**STRUCTURAL NOTES**

- A. PROJECT REFERENCES:**
- 1. **CODE:** WORK SHALL BE EXECUTED IN FULL COMPLIANCE WITH THE APPLICABLE PROVISIONS OF ALL LAWS, BY-LAWS, STATUTES, ORDINANCES, CODES, RULES, REGULATIONS, AND LAWFUL ORDERS OF PUBLIC AUTHORITIES BEARING ON THE PERFORMANCE AND EXECUTION OF THE WORK.

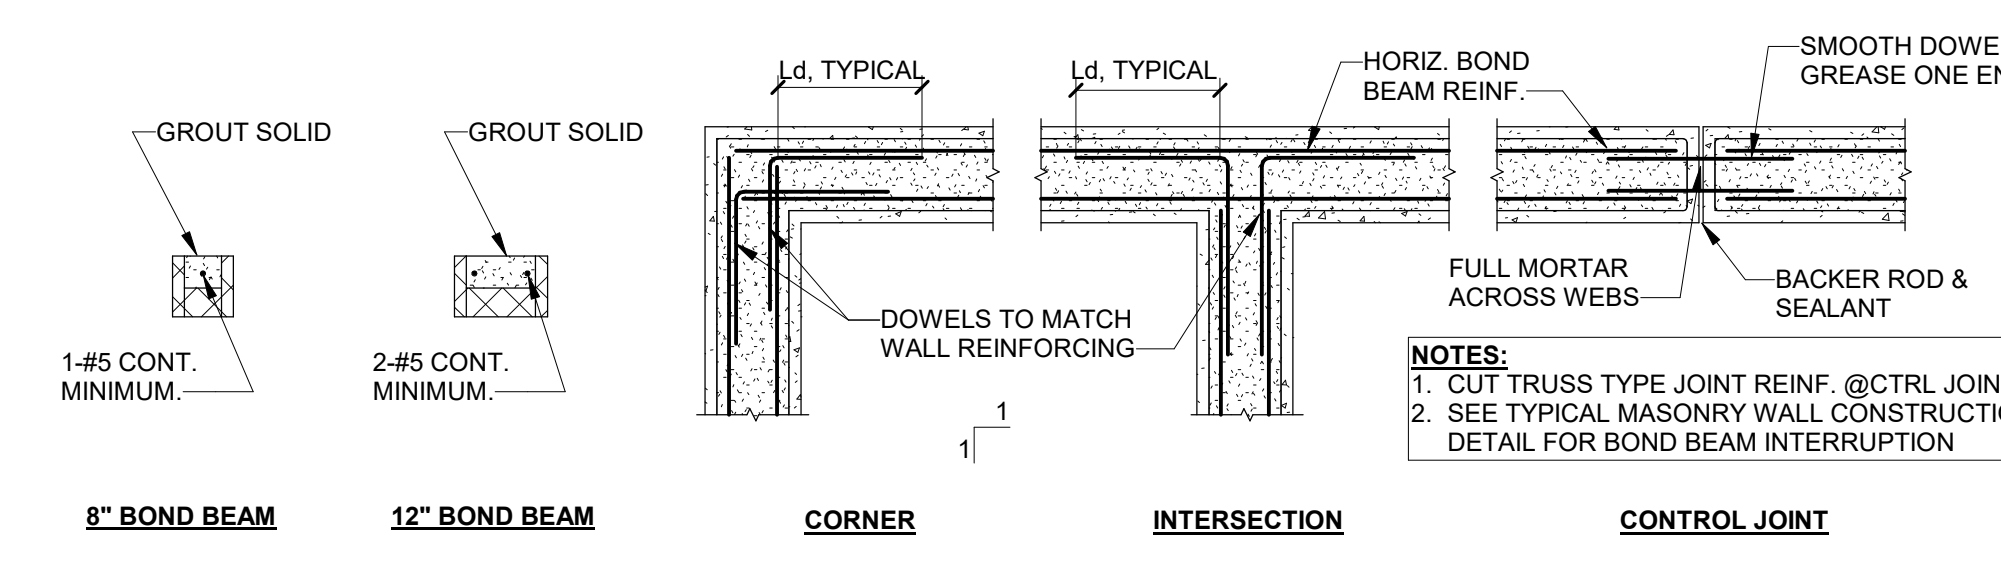
DATE	ISSUED FOR	REV
2026.03.04	BIDDING	A
2026.04.28	PLAN REVIEW	B
2026.06.18	REISSUED FOR BID	C

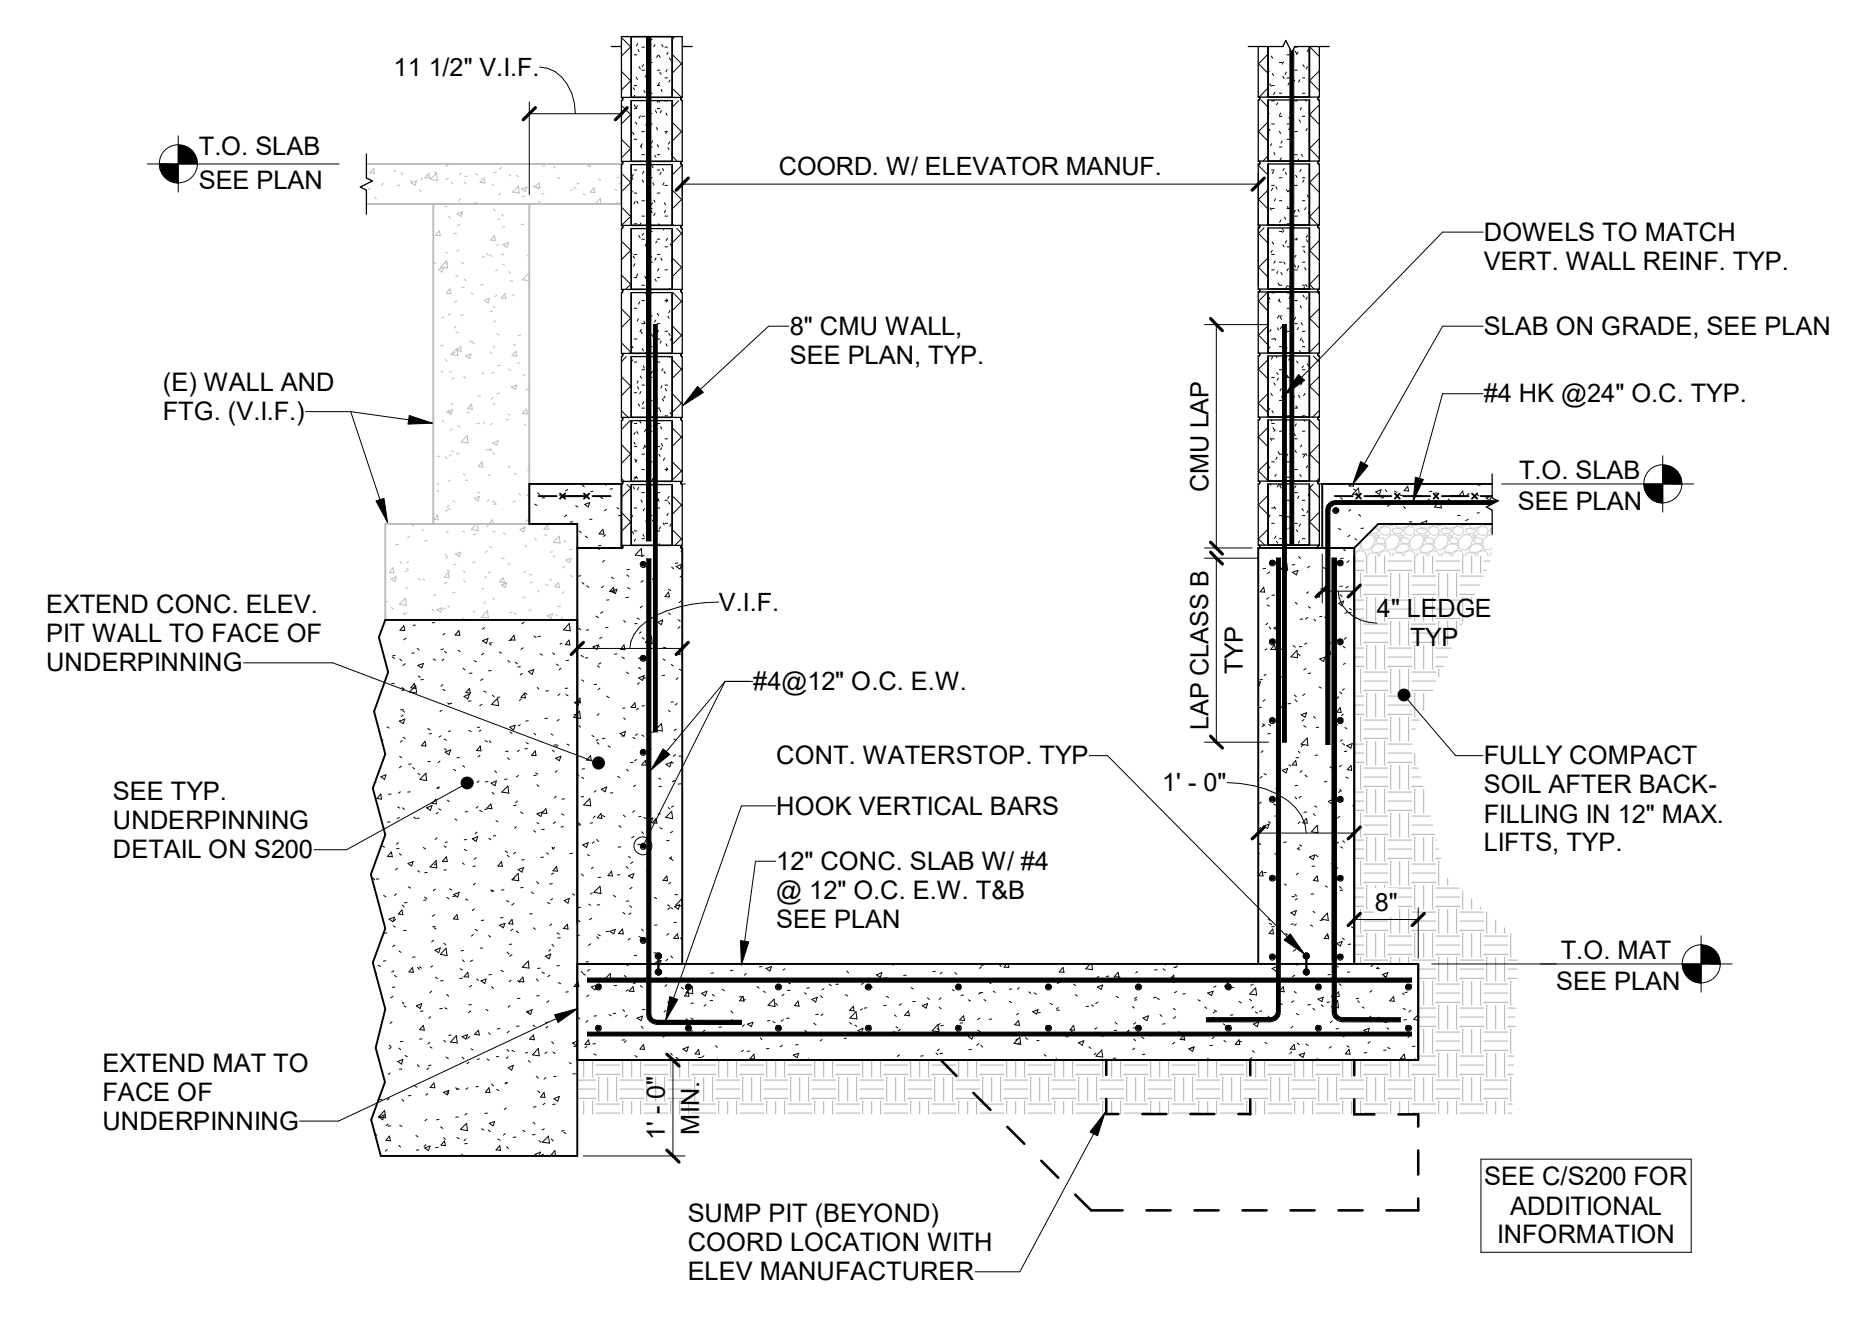
DATE	ISSUED FOR	REV
2026.03.04	BIDDING	A
2026.04.28	PLAN REVIEW	B
2026.06.18	REISSUED FOR BID	C
